Kitsap County Department of Community Development

Administrative Staff Report

Project Name: Hansen Self Storage

Permit Number: 18-00850

Landscape Plan

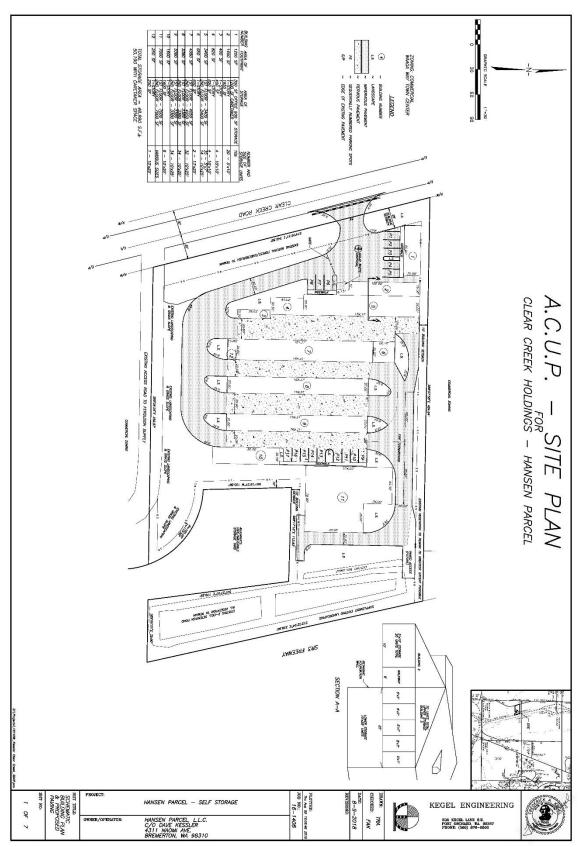
There is also landscaping proposed to climb up trellises attached to the proposed buildings to break up the façade and building mass. The plantings associated with the trellises have not been shown on the landscape plan because the buildings have not been designed yet. As a result, the trellis plantings will need to be provided with each building permit.

The proposed 6-foot solid board fence along the north property line from the northwest corner for approximately 100 feet to the east shall be extended approximately 50 feet for a total of 150 feet to extend past Building 5. This is to provide appropriate screening to the residential use of the property to the north. Because the property to the north is zoned C, the same as the subject property, it is not appropriate to require a solid screening buffer, which is generally required between different uses. The landscape plan submitted with SDAP 18-00853 will be required to show the 150 feet dimension for the solid board fence.

All fire hydrants will be required on the landscape plan submitted with SDAP 18-00853.

The irrigation plan as submitted is sufficient for the proposed landscaping shown because the drip irrigation system will be installed after all the plants have been planted. However, separate irrigation treatment will be required for each building permit to demonstrate sufficient watering requirements for the trellis plantings.

Staff Response: A planting island has been shown as required; Kitsap County Code 17.490 has additional landscaping requirements for parking areas. The applicant has demonstrated compliance with code and design district requirements as shown on the preliminary landscape plan, 3rd submittal, dated 08.10.2018.

Staff Response: Only one building frontage has at least 6 stalls. The required planting strip has been shown on the preliminary landscape plan, 3rd submittal, dated 08.10.2018. The required irrigation has also been shown on the referenced plan.

Three light standard locations, one at the entrance, one near the southwest end of Building 5 and south of parking space 8, and one on the north side of Building and on the south side of parking space 17, have been shown on the landscape plan, 3rd submittal, dated 08.10.2018. The "cut sheet" for the proposed light standard shall be submitted with SDAP 18-00853. It is anticipated that lighting will also be provided on each building. Building lighting shall be shown on the initial building permit for each building. Exterior lighting needs to be fully recessed or fully shielded from side view and directed downward and away from surrounding properties. No more than one foot-candle of illumination shall leave the property boundary.

- 9. A final landscape plan shall be submitted with SDAP 18-00853. The final landscape plan shall comply with Kitsap County Code (KCC) 17.500 and Silverdale Design Standards for district Waaga Way Town Center (WWTC). In addition to the information shown on the preliminary landscape plan, 3rd submittal dated 08.10.2018, the final landscape plan shall also show:

- 10. Trellises with climbing plantings shall be required for each building façade greater than 50 feet in length. Attached buildings shall be considered and measured as one building. The approved final landscape plan and a separate landscape plan that shows the trellises and climbing plants shall be submitted with each building permit.
